Welder WPS Qualification Statement – Mary River Project 2011

## **A.1 RFI's and Correspondance**

# MILNE INLET FUEL SYSTEM

# UPGRADE

Drawing H337697-4020-10-035-0002 - Section-D (Dyke Construction)

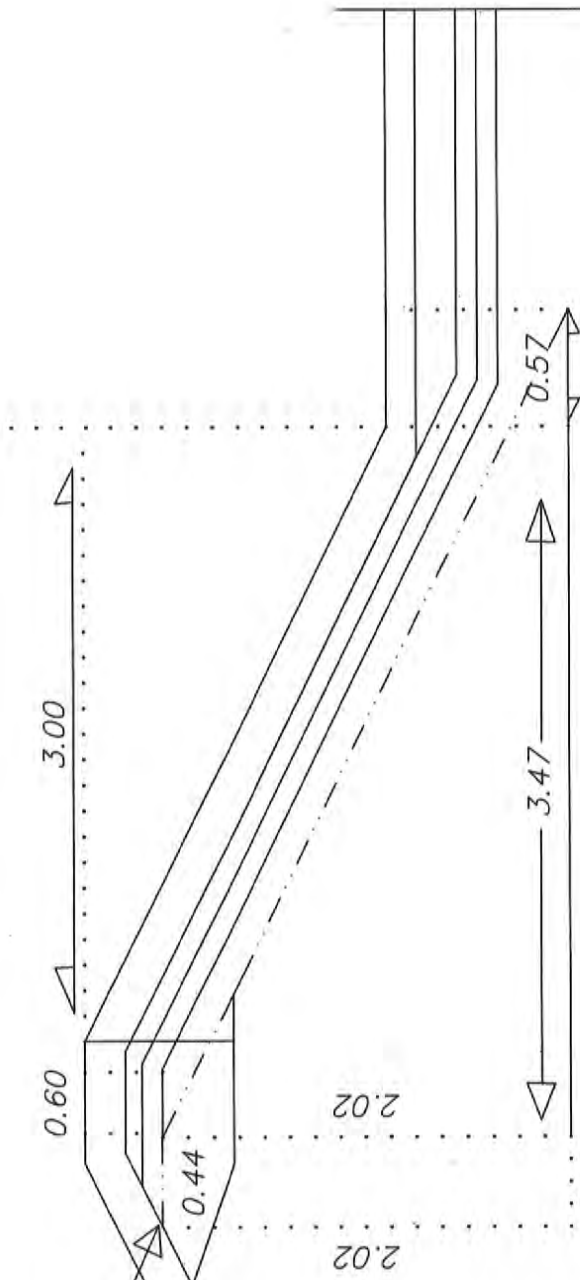
construction requires a Key Trench to allow for Liner to be held securely in place.

"Type-2" material to be placed above "Type-4" material, "Type-2" material is to be screened as per spec, which would hold up construction as the screener will arrive on sea lift.

slope, then flat, then back to a 2:1 slope.

D) Construction under tank pad calls out for Insulation to sit on 100mm of Type-6 Sand.

A) Dyke

B) Dyke requires

C) "Type-4" subbase requires 2:1

A) Key Trench can be removed. Liner would then continue over the top of the dyke onto outside. To hold liner securely in place, it would be backfilled on top of liner on the outside of the dyke.

Current material being used out of Km2 Borrow Pit is very close to the spec'd "Type-2" material. It has proven to compact extremely well as demonstrated to Hatch on site.

C) See attached

sketch for proposed slopes as the Key Trench will no be required.

D) Place Insulation

directly on top of Geotextile. This will gain more material above Insulation, which will allow for more protection of material during construction.

A - HMM will allow this design change provided the costs associated with the additional liner required to extend to the outside toe of dyke are bore by the contractor. Documentation from the liner manufacturer shall be provided indicating this is an acceptable means of backfilling.

B - Granular Type-2 substitution with Bank Material out of Km2 Borrow Pit is approved pending documentation from Hatch site staff indicating its adequacy for use within the dyke construction.

C - Revised dyke wall granular configuration with Granular Type-4 sloping as per attached sketch is approved for construction. D - Insulation location shall remain as per current design. Relocating insulation below a layer of bank material (Type-2 Substitute noted in point B) could damage the insulating layer.

### DETAIL-6

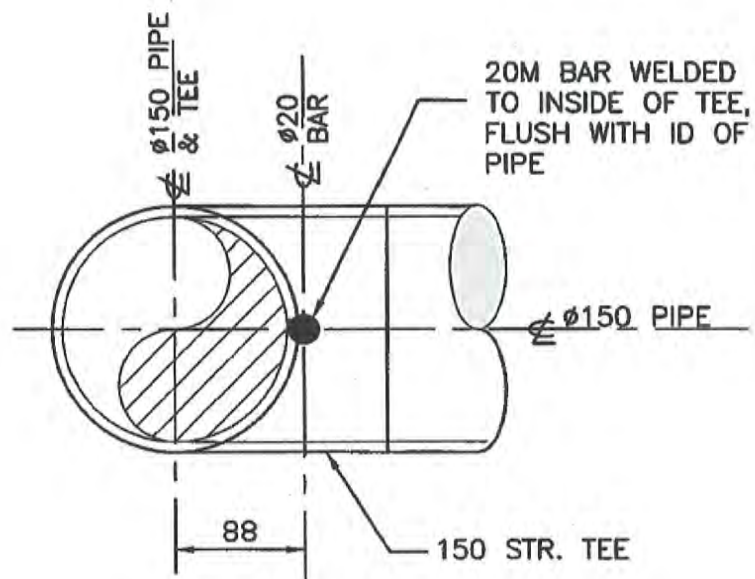
<b>RESPONSE:</b> CORRECTIVE ACTION APPROVED <input type="checkbox"/> CORRECT AS FOLLOWS <input type="checkbox"/>				
Detail for tee branch bars is attached. Add additional branch bars at on the branch of the tees for the future tank connections. (4 locations)				
<b>Patrick Coshin</b>		<b>Patrick G. Cool</b>		<b>Project Engineer</b>
Name (print)		Signature		Title
Estimation required from Contractor:		<input type="checkbox"/> Yes	<input checked="" type="checkbox"/> No	
Change Order to Contract Required		<input type="checkbox"/> Yes	<input checked="" type="checkbox"/> No	
Site Instruction #:		Date Issued:		
Adco Project Representative:		Name: <b>Terry Oszust</b>	Signature:	Date: <b>August 29, 2011</b>

TYPICAL Ø150 PIGGING TEE  
 REFER H337697-4020-60-013-0001  
 SCALE: 1:5

18/30, 2011  
 DWG No.  
 4020-60-035-0001  
 DETAIL-6 ADDED
